Manual 15

Biennial Review Changes

Action Required	Deadline	Who May Be Affected
Review Manual 15 updates	08/07/2024	Market Sellers

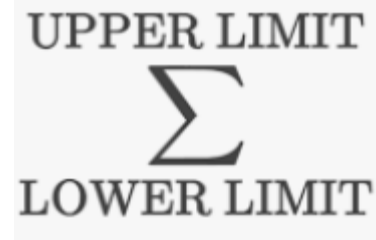
Move up to correct location

~~Exhibit 26: Name to be determined~~

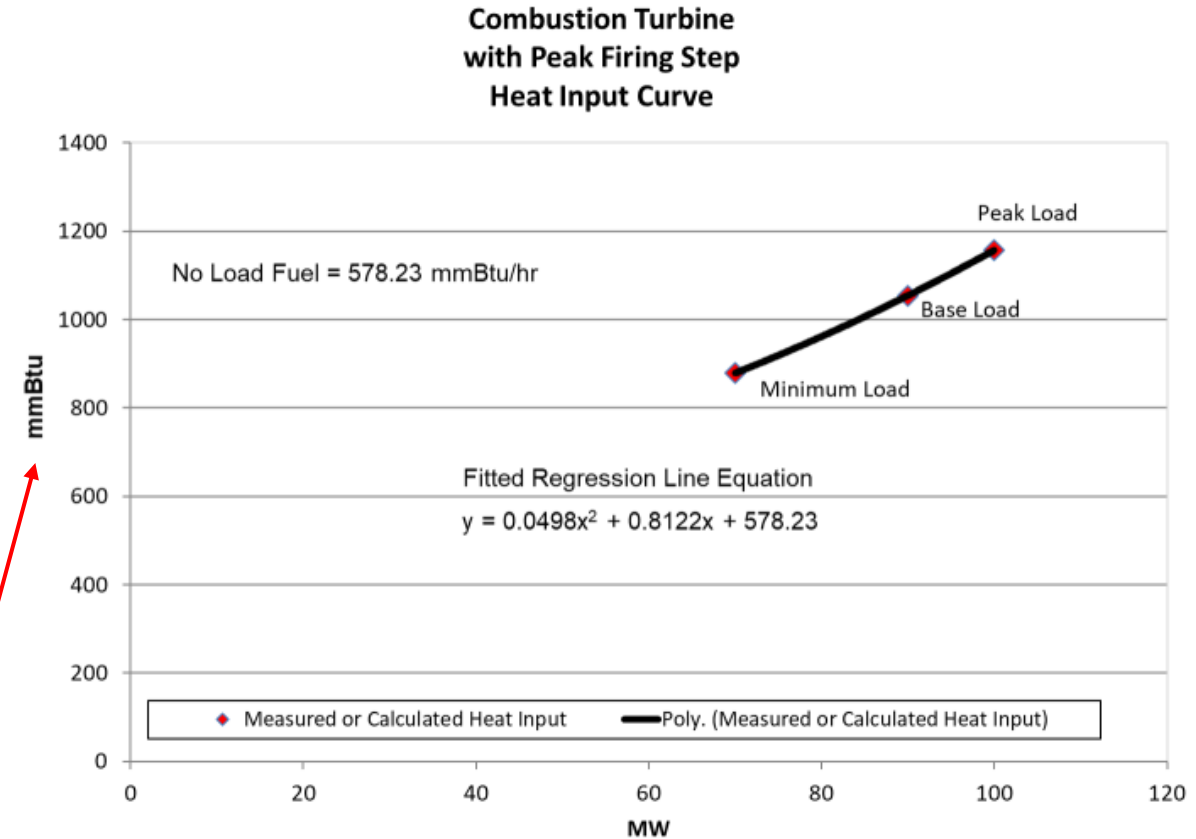
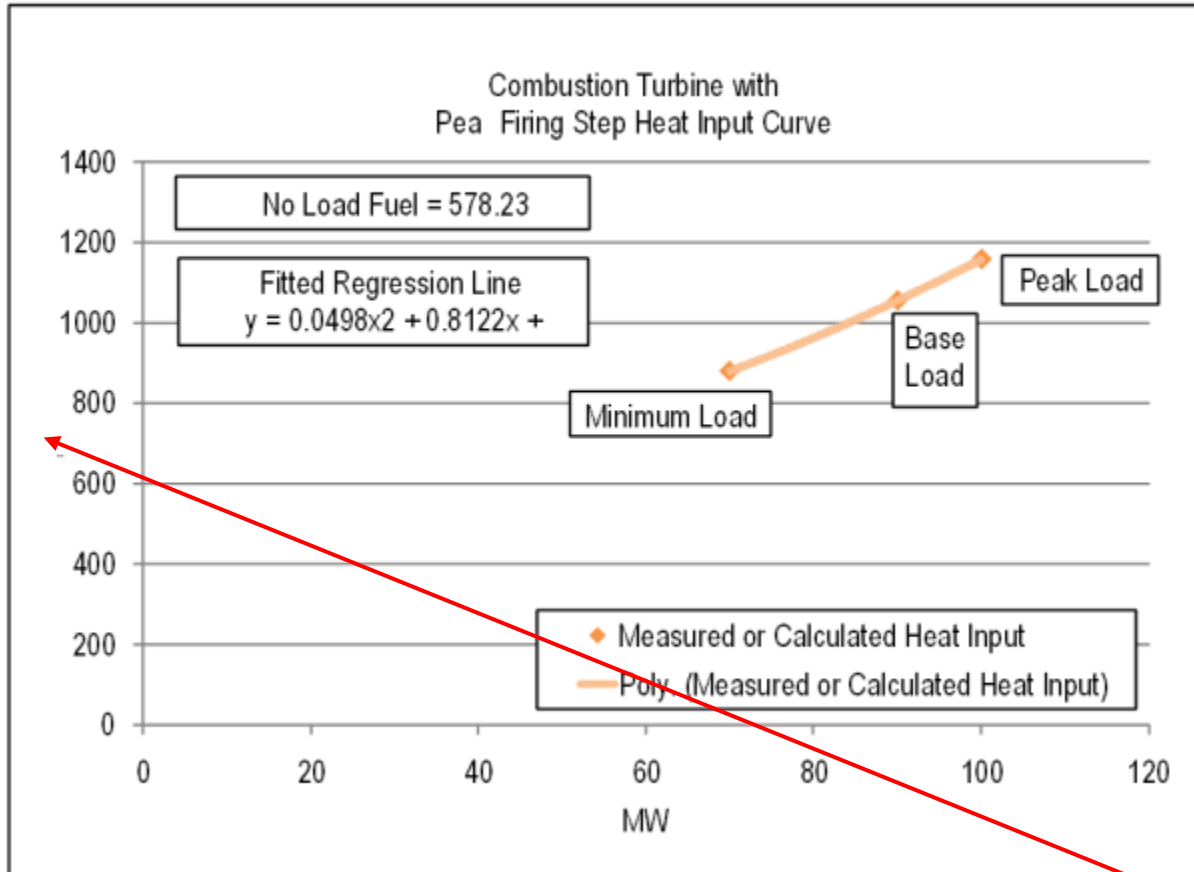
Replace any graphs with missing Y-axis labels
